Model: Stella-F1		Date: 21-Feb-02	No.: RH555001
Subject: Optional Printer Controller		Prepared by: A. Ishiyama	
From: Technical Services Dept., GTS Division			
Classification:	<input checked="" type="checkbox"/> Troubleshooting <input type="checkbox"/> Part information <input checked="" type="checkbox"/> Action required <input type="checkbox"/> Mechanical <input type="checkbox"/> Electrical <input type="checkbox"/> Service manual revision <input type="checkbox"/> Paper path <input type="checkbox"/> Transmit/receive <input type="checkbox"/> Retrofit information <input type="checkbox"/> Other ()

Please note the following when installing the optional Printer Controller in the model S-F1.

Model: Model S-C1 Printer Option	Date: 11-May-04	No.: RB044011b
----------------------------------	-----------------	----------------

Subject: Printer Controller Firmware History		Prepared by: A.Ishiyama	
From: 1st Tech. Support Sec. Service Support Dept.			
Classification:	<input type="checkbox"/> Troubleshooting	<input type="checkbox"/> Part information	<input checked="" type="checkbox"/> Action required
	<input type="checkbox"/> Mechanical	<input type="checkbox"/> Electrical	<input type="checkbo

Case A:

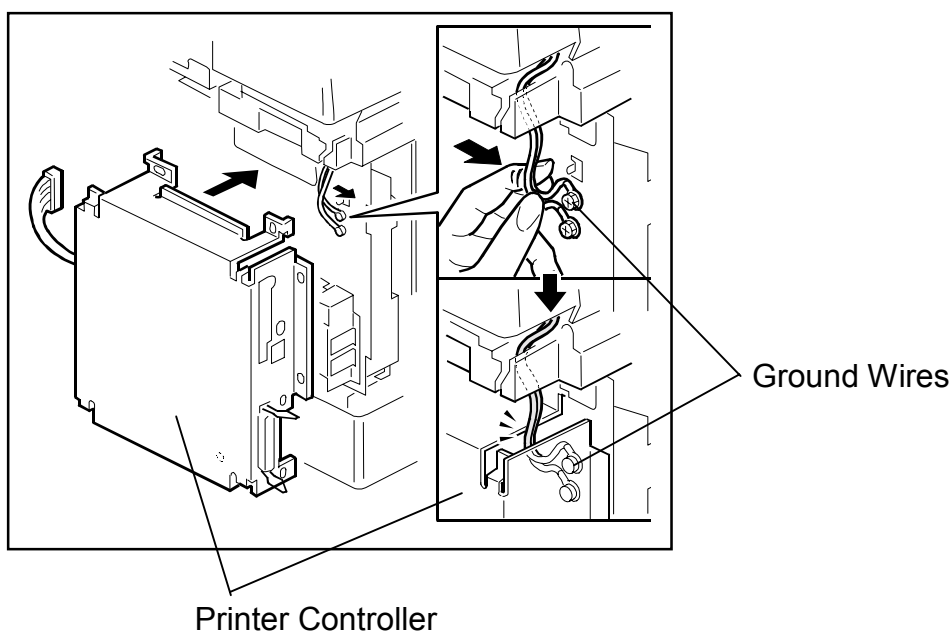
After installing the printer controller in Step 5 of the Installation Procedure, the ADF unit does not open all the way.

When the Controller was installed, the 2 ground wires were not led through the inlet (opening) in the upper right corner of the controller bracket, causing excess tension on the wires.

When installing the Printer Controller, be sure to set the wires into the opening in the upper right of the bracket as shown below. This will prevent excess tension on the wires and allow the DF to fully open.

Case B:

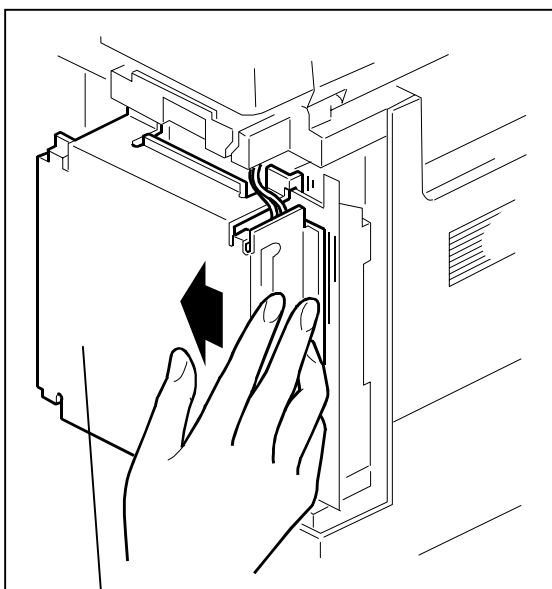
After installing the Printer Controller in Step 5 of the Installation Procedure, the 3 screw holes on the main face of the Rear Cover do not line up with the mainframe holes, making it difficult to reattach the cover.

When the Controller is attached slightly right of center, the width and circular (top) screw holes of the Rear Cover do not provide enough clearance for left/right cover adjustment, and the two contact one another.

When attaching the Controller, hold it flush against the left while tightening the bracket screws as shown in the illustration below.

The shape of the upper screw holes on the main face of the Rear Cover will be changed from circular to elliptical (running change) to allow for any necessary left/right adjustment.
